AIRSPACE CHANGE PROPOSAL ACP-2019-58 LLANBEDR AERODROME DANGER AREA – SUMMARY OF DESIGN OPTIONS AND INITIAL APPRAISAL

Figure 1 – Draft airspace design Option #1 for ACP-2019-58, Llanbedr Danger Area (DA)

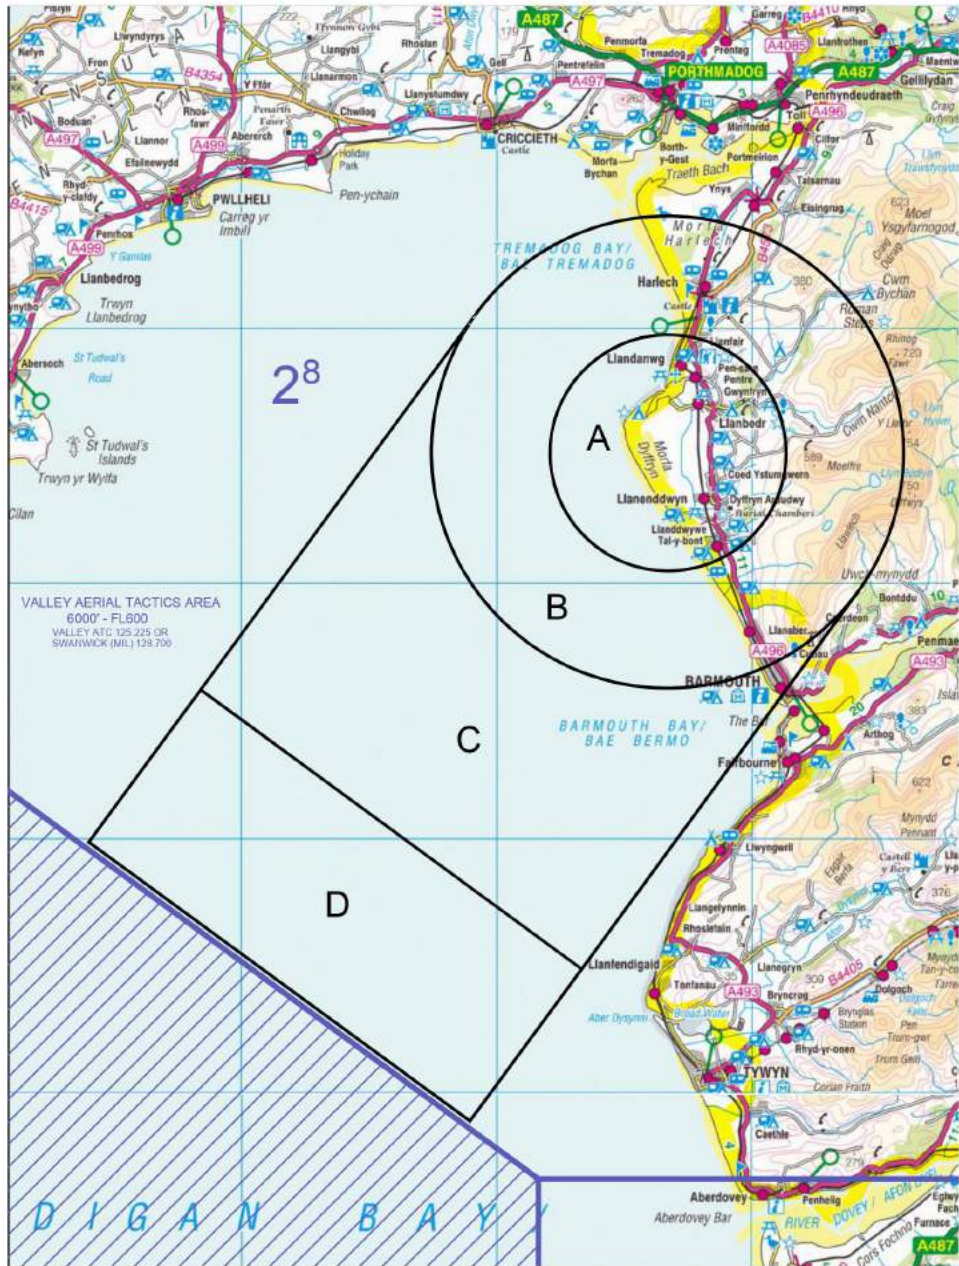
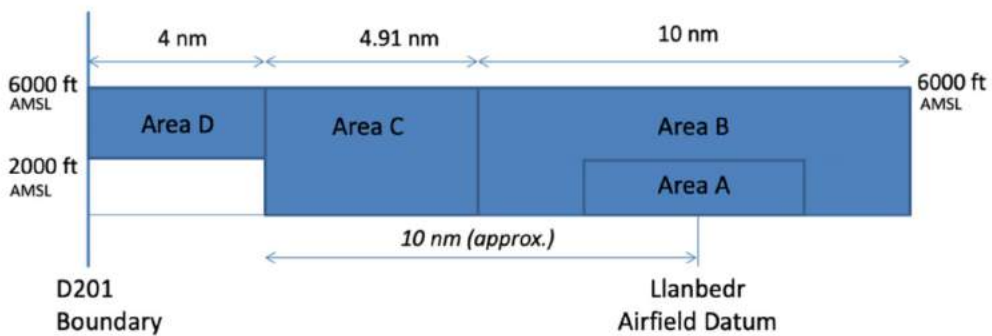
3. *Airspace Options: (a) Noting that both airspace options are for Danger Areas. Did you consider the acceptability of a Transponder Mandatory Zone or a Radio Mandatory Zone? Or a change in classification of airspace? (b) Whilst more complex, the MOD would prefer the more dynamic Option 2. What UAS have you used to come up with the design? Noted in your design that the areas may be activated between 2000' and 6000' – would you propose to use altitudes between or would it be one or the other? What proportion of the time do you think the airspace will be activated above 3000'? The MOD would require a LOA to ensure any activation above 4000' is deconflicted with Valley GH C (as per the VATAs) operations.*

The design options have been promulgated as Danger Areas (DA), rather than as Radio or Transponder Mandatory Zones (RMZ/TMZ) in order to be compliant with CAA CAP722 Unmanned Aircraft System Operations in UK Airspace – Guidance & Policy. CAP722 states that “Unless able to comply with the current requirements of the Air Navigation Order (ANO), including the Rules of the Air, Unmanned Aircraft System (UAS/drone) flights which are operated beyond the visual line of sight (BVLOS) of the remote pilot are required to be contained within segregated airspace. The UK uses DAs as the primary method of airspace segregation for UAS operations”.

We have not used any individual UAS/drone specification to drive the DA airspace design because the performance and test and evaluation requirements of all the anticipated future types will vary significantly. Instead we took inputs from multiple different potential users and have sought to balance the requirements for novel aerospace RDT&E, the need for flexible use of airspace (via segmentation), the desire to minimise the number of requests to AROPs for Temporary Danger Areas and the need to provide the growing novel aerospace sector with a surety of being able to operate in the UK on a reactive basis. The justification for lateral and vertical dimensions of both DA options has been detailed in the formal Stage 2A Options Development document that can be accessed via the online portal.

As noted in (2) above, we anticipate operations above 2000ft roughly once every 10 days or so and will only segregate the minimum amount of airspace required at any given time – i.e. we would propose to use altitudes between 2000ft and 6000ft as required. Activation above 4000ft is therefore unlikely to cause a significant schedule conflict for RAF/MOD training and we are confident that all coordination and operational integration issues can be managed via LOA.
